**PLANNING DIVISION REPORT
DEPARTMENT OF PLANNING AND COMMUNITY
AND ECONOMIC DEVELOPMENT
December 1, 2008**

RE: LD. # 12299: Zoning Map Amendment LD. 3391, Demolition and Rezoning of 1308 West Dayton Street from R6 and C2 to PUD-GDP

DATE: November 17, 2008
TO: Plan Commission
FROM: Larry D. Nelson, P.E., City Engineer
SUBJECT: 1308 West Dayton Demolition and Rezoning

TO: Plan Commission
FROM: Timothy Sobota, Transit Planner, Metro Transit
SUBJECT: **1308 W Dayton Street – Demolition & Rezoning – “New South Campus Union”**

- "Current Metro Transit operations" diagram
- Sketch on site plan showing proposed bump-out on Campus Drive

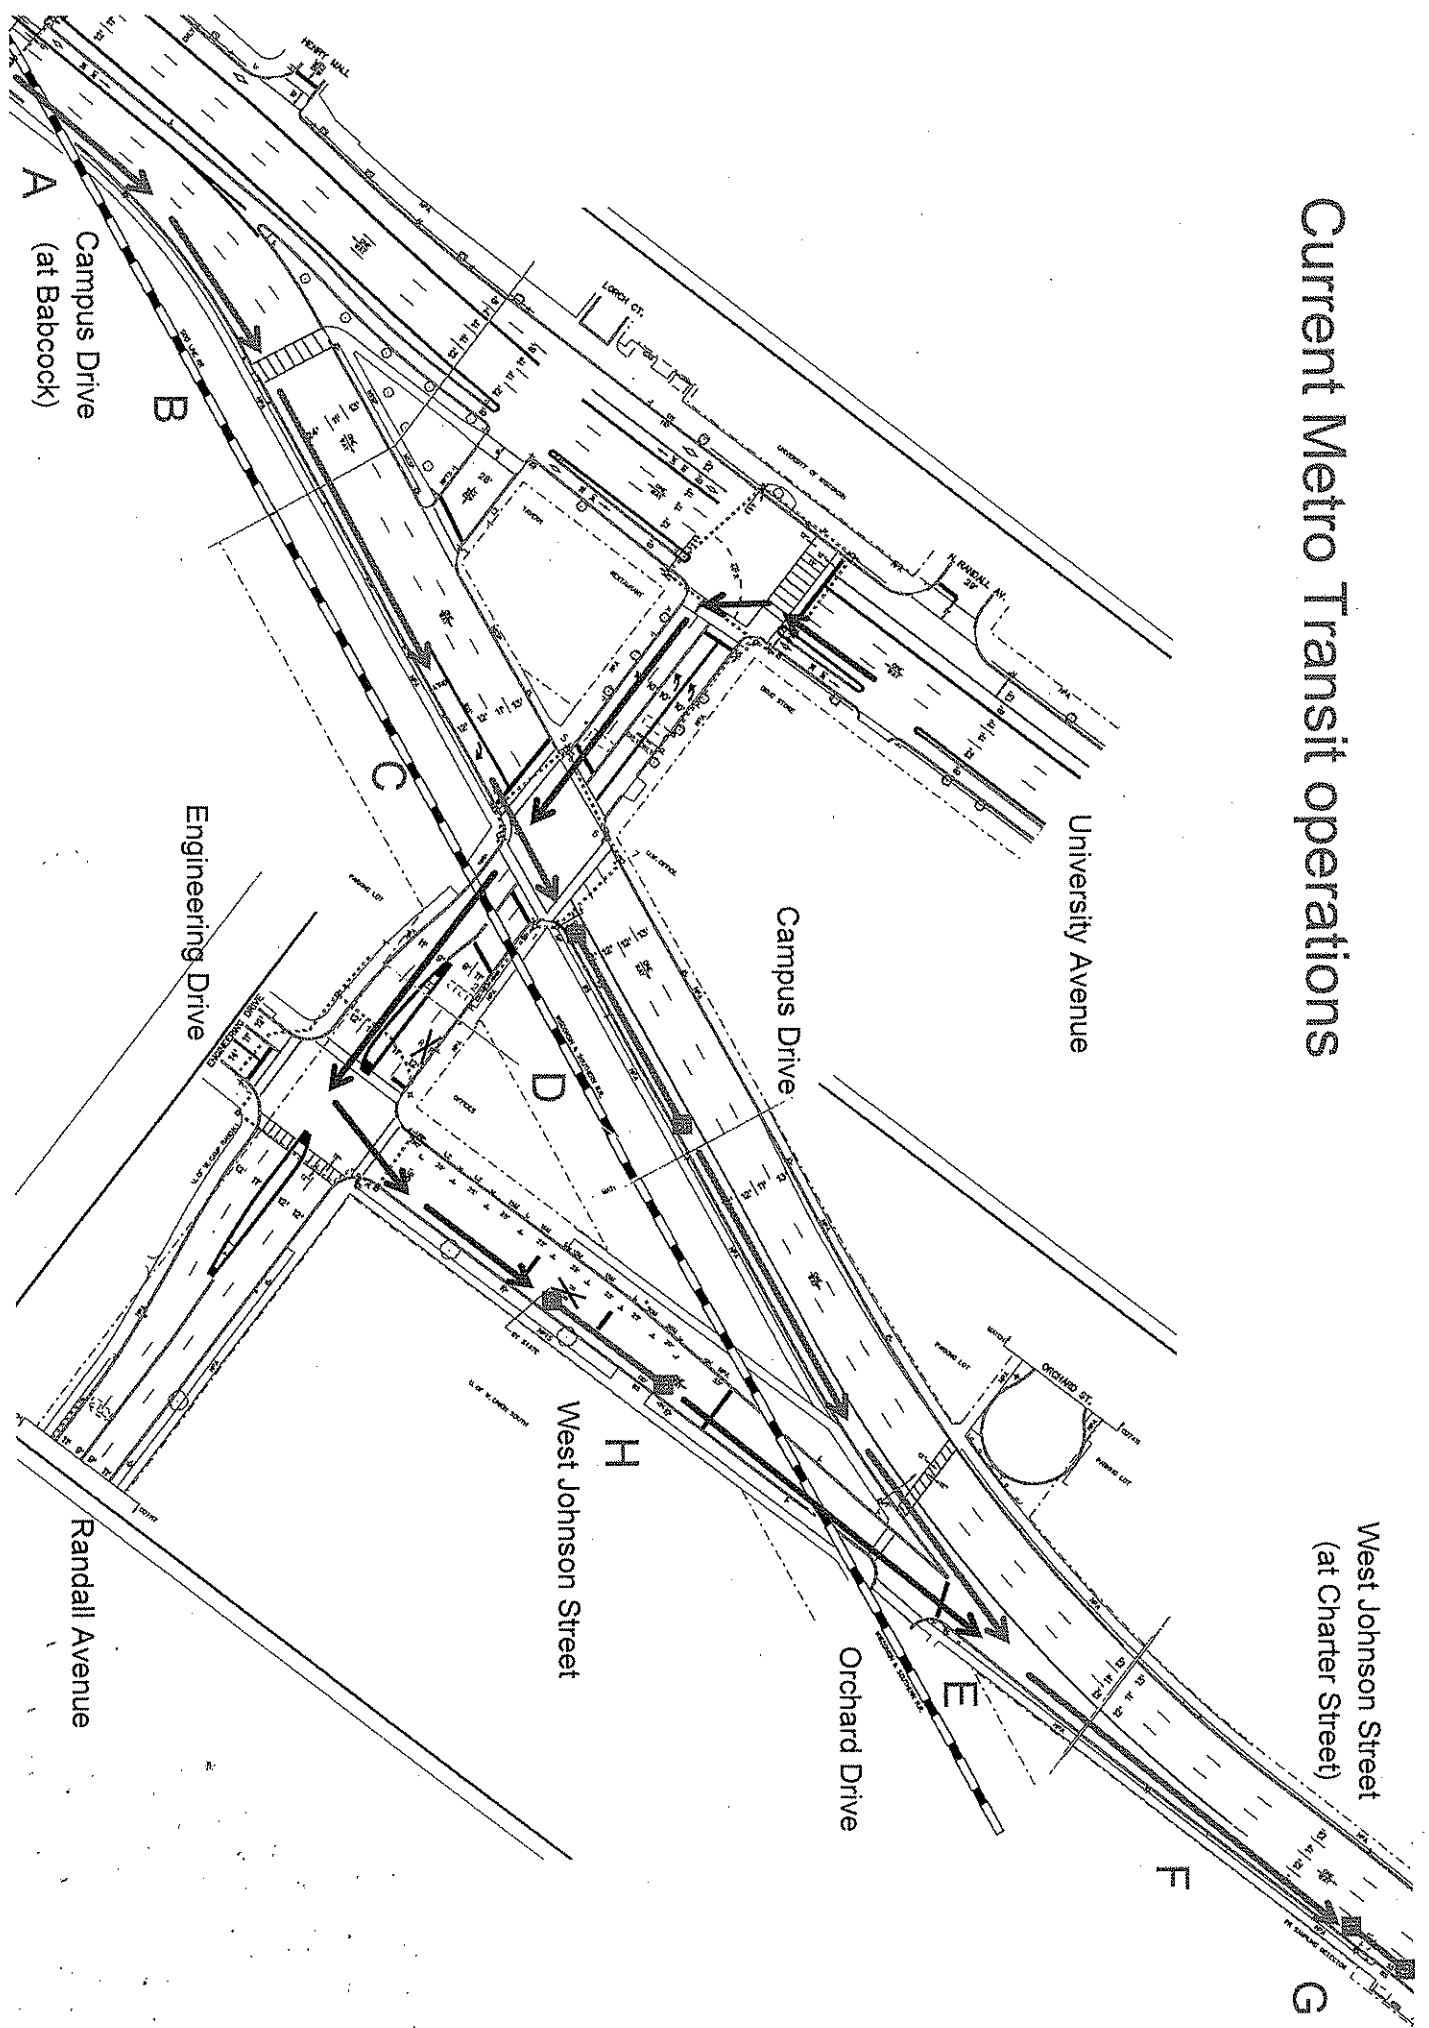
1. The proposed intersection configuration of Campus Drive and Randall Avenue shown on the site plans would eliminate the existing bus stop location on the south side of Campus Drive, east of Randall Avenue. This stop that would be eliminated serves the current Union South and adjacent properties, and would have otherwise directly served the proposed New South Campus Union, as well as the new WIDMIR site across the street. Elimination of this stop would also be contrary to the conceptual plans for the Transport 2020 commuter rail project, which anticipated direct passenger transfer opportunities between the train platform and local bus services at this stop location.

4. Metro Transit feels it is critical to continue to be able to provide convenient transit service to the major trip generators of the expanded student union, as well as the WIDMIR project on the opposite side of Campus Drive. However, the extent to which the site plans show modifications to roadway capacity on both Randall Avenue and Campus Drive to accommodate an increase in car traffic directly eliminates current transit operations and moreover precludes any safe or efficient alternative options.

5. Metro Transit would request that the Plan Commission adopt a recommendation to the Board of Public Works and ultimately the Common Council in support of a physical traffic barrier being installed in the traffic lane on Campus Drive, that would create a safe bus stop zone near Orchard Street as identified in item 3 above.

the south curb line of Campus Drive (B), and approach the Randall Avenue intersection in the designated right turn only lane (C/[Image link](#)) that is added here (buses are exempt from this right turn requirement, which provides a travel time advantage for bus passengers to the extent the three through lanes of Campus Drive are more heavily congested). Buses continue straight through the intersection from this curb lane to the current bus stop location serving the Randall Avenue intersection and Union South area (D/[Image link](#)), which is delineated from the three through traffic lanes of Campus Drive by a solid white line. This dedicated lane marking allows not only a protected zone for loading and unloading the approximately 600 passengers per day who use this stop, but also affords buses a scheduled layover spot (as published in the Ride Guide bus schedules) and a location from which various routes can start trips (both instances where a bus may have occasion to park for three to five minutes before departing). The dedicated lane marking continues on Campus Drive through the current intersection with West Johnson Street, where traffic eastbound on West Johnson Street is required to yield to buses traveling along Campus Drive (E/[Image link](#)). Buses continue east towards their next stop as the lane marking transitions to a dashed line (F). The next bus stop is in the curb lane on the south side of West Johnson Street, west of Charter Street (G/[Image link](#)). The stop at Charter affords similarly important pedestrian access to the extent Charter Street extends north of University Avenue towards Van Hise Hall and Observatory Drive. In addition to the bus operations along Campus Drive, the UW Route 80 currently has evening trips that travel west of Charter Street along University Avenue and Randall Avenue to serve the bus stop location on West Johnson Street east of Randall Avenue (H/[Image link](#)). Buses make similar use of this location, as a protected stop zone, for scheduled layover and other short-term parking requirements (i.e. driver breaks).

8. Elimination of the bus stop on Campus Drive east of Randall Avenue would leave an approximately 1/8th mile or 700 foot walking distance from the project site back to the previous stop location near Babcock Drive. The walking distance from the northeast corner of the development parcel (West Johnson Street at Orchard Street) to the next bus stop at Charter Street would be approximately 350 feet. The distance between these two remaining bus stop locations at Babcock and Charter (due to the elimination of the stop at Randall) would be just over 1/4 of a mile in total.
9. Metro Transit requests to sign and review final documents submitted for this project.
